Service Bulletin

Bulletin No.: PI0961

Subject: SERVICE HIGH VOLTAGE CHARGING SYSTEM Message Displayed on Driver Information Center (DIC), Hybrid/EV Charging System Disabled, DTCs Set

Models: 2013 Chevrolet Volt
Vehicles Built Prior to February 5, 2013

3347990

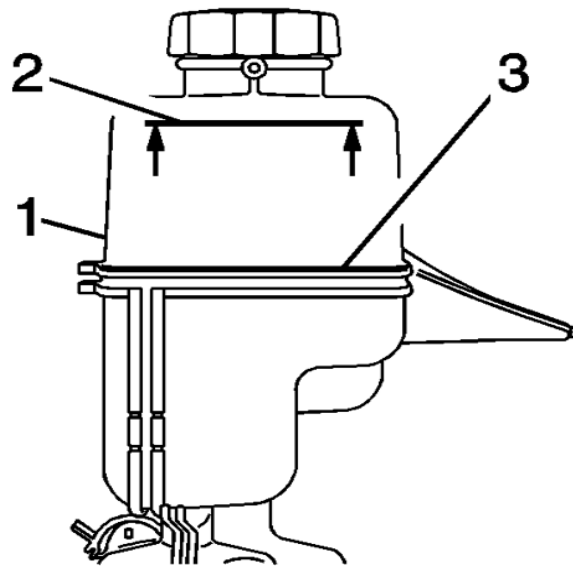
Notice: When checking and adjusting the high-voltage (HV) battery surge tank (1) coolant level, disregard the factory level indicator markings (2). The proper coolant level is at or just above the top of the seam (3).

- 0.5. Visually inspect the coolant level in the high-voltage battery surge tank (1) and verify that the level is at or just above the seam (3).
 - ⇒ If the HV battery surge tank (1) coolant level is not **at or just above** the seam (3), Go to: Hybrid Cooling System Loss of Coolant (Battery) in SI.

- ⇒ If the HV battery surge tank (1) coolant level is **at or just above** the seam (3), Go to Step 6.
- 0.6. Remove the front compartment front sight shield. Refer to Front Compartment Front Sight Shield Replacement in SI.
